Channel Mitigation Monitoring Sheets I, II, III, AND IV

Project Title: K-3800 UT to Maple Branch COE Action ID: SAW 2013-02202
Stream Name: UT to Maple Branch DWR Number: 20130649
City, County and other Location Information: The project is located on the east side of US 17 at the intersection with Harding Road, south of Chocowinity in Beaufort County.
Date Construction Completed: _____ Final Planting: December 10, 2014
Monitoring Year: (2) of 5
Ecoregion: Mid Atlantic Flatwoods 8 digit HUC unit 03020104
USGS Quad Name and Coordinates: NC-Hackney 35.492064, -77.105281

K-3800 Beaufort County Rest Area

NCDOT is requesting a revision to the scheduled maintenance for Areas “A” and “B” as depicted on the attached map and in the attached maintenance schedule.

Exhibit 2. K-3800 Beaufort Co Rest Area Mitigation Site Plan

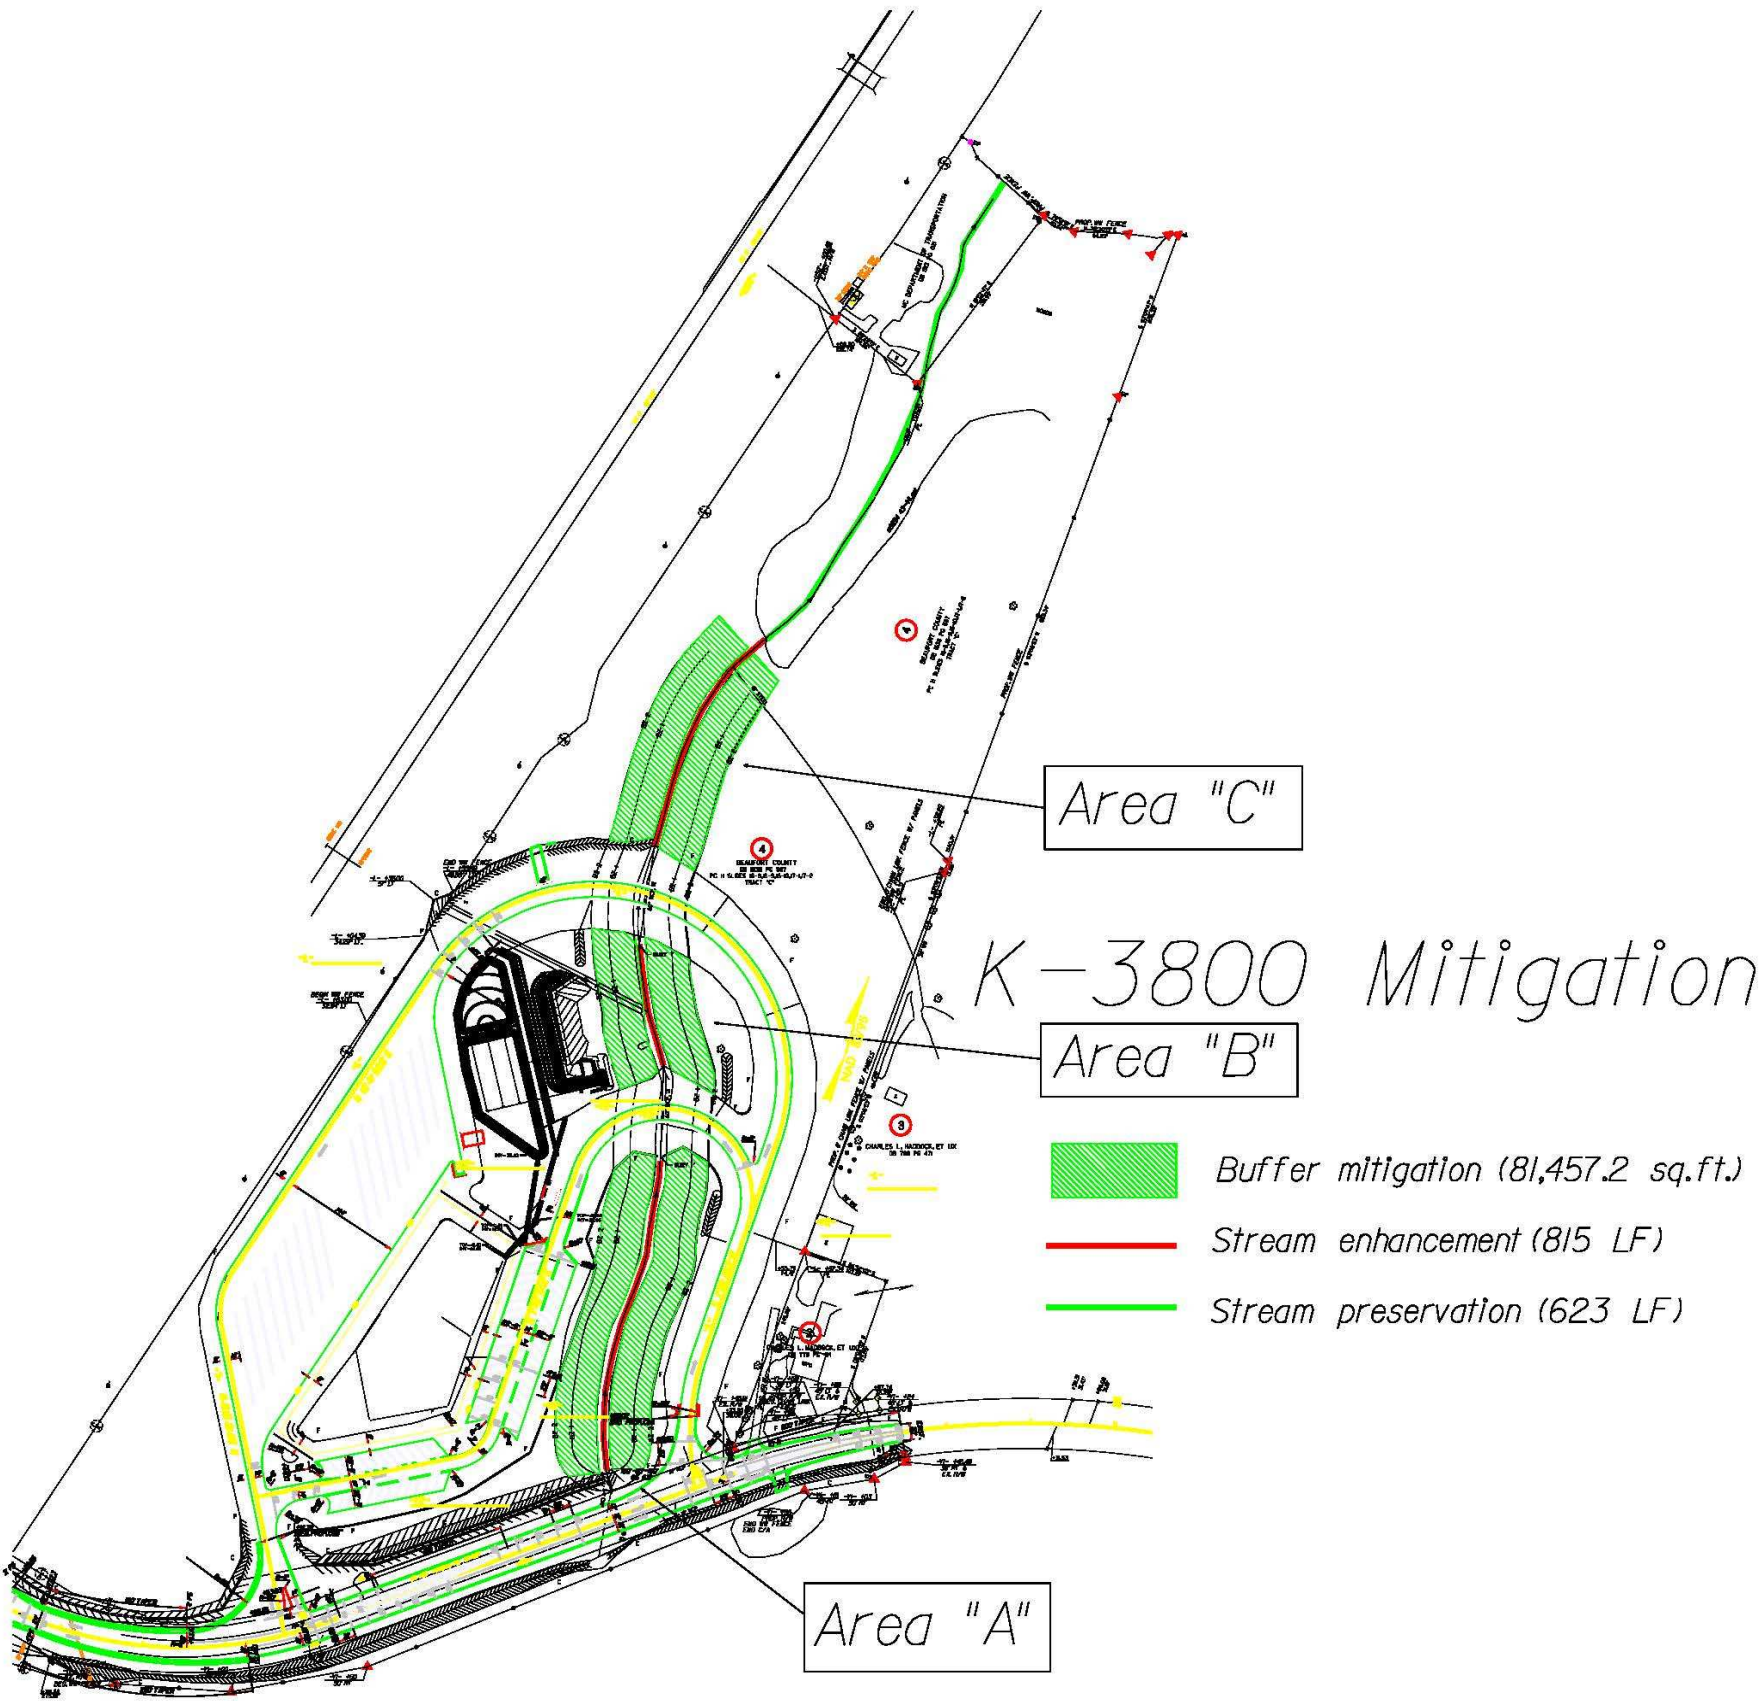
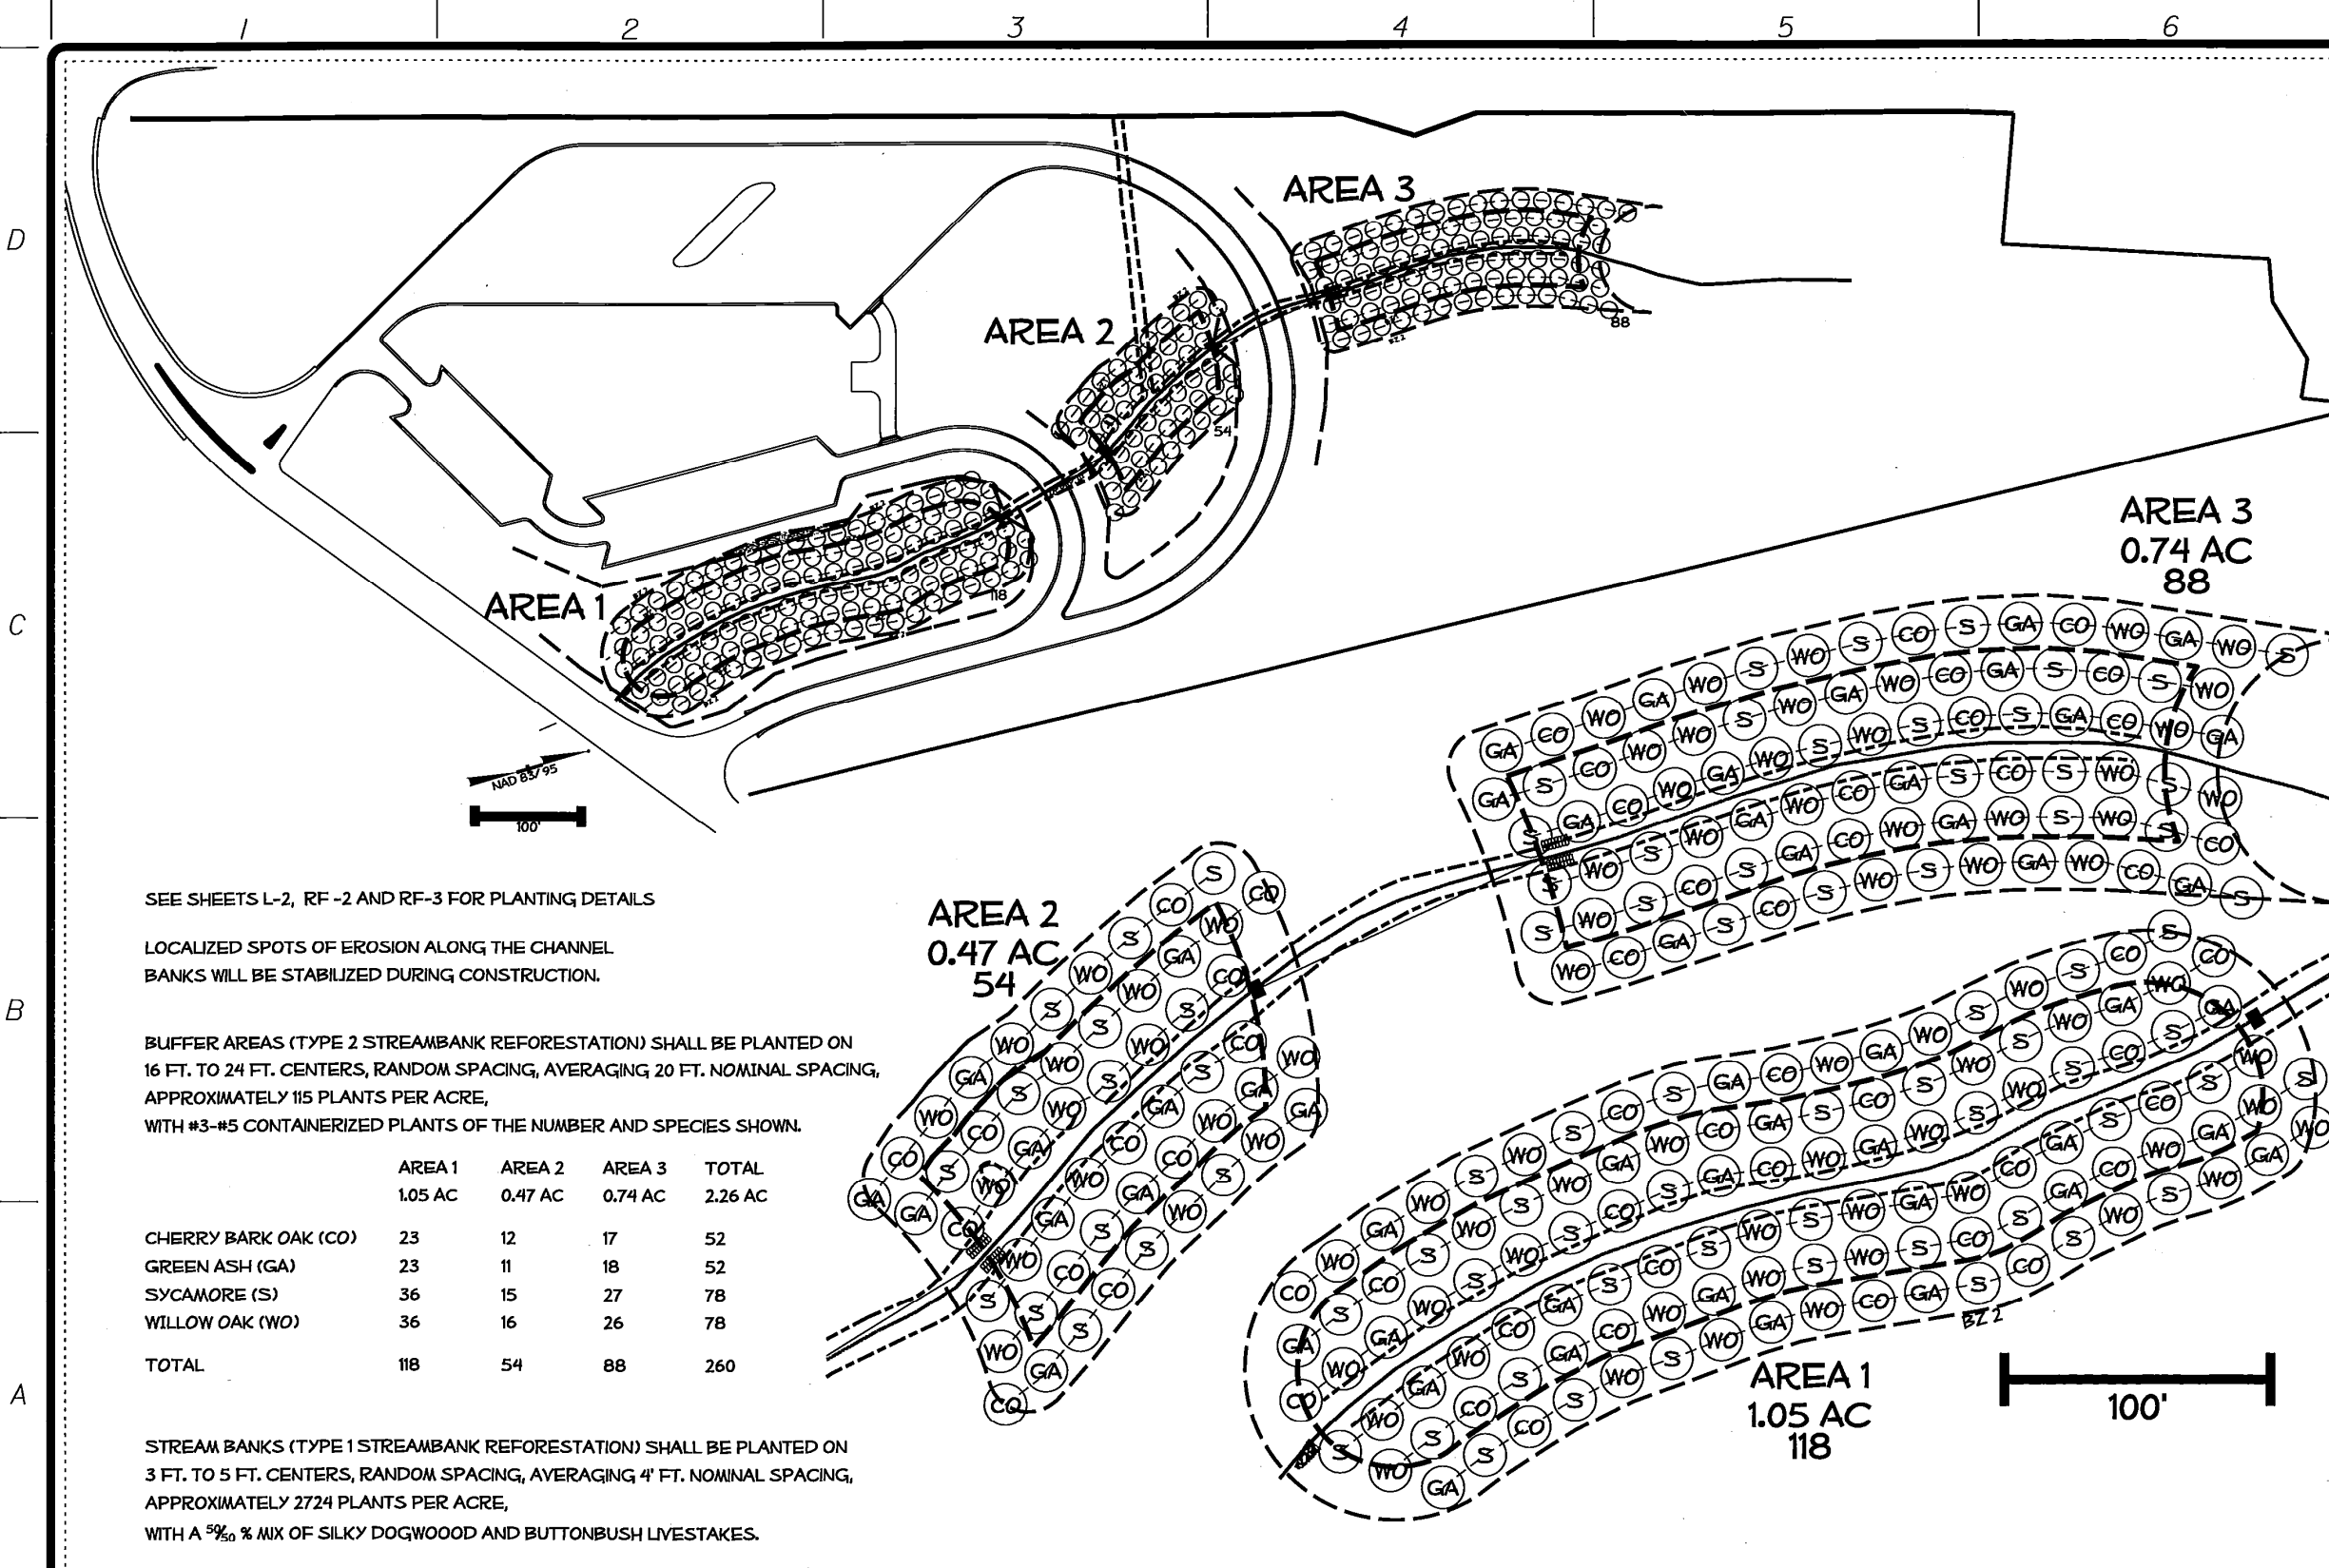
As part of our request, NCDOT is proposing to allot the remaining buffer mitigation to this project.

It was determined during discussions with DWR that the planting density associated with the buffer mitigation plan was sufficient for this site.

This planting density is currently 115 trees/acre. The trees that were planted in this buffer area were 3 gallon containerized material.

Success criteria for planting densities for this site will be adjusted to reflect this change in planting density. NCDOT proposes that the site meets vegetation success criteria if 115 trees/acre are surviving after 5 years.
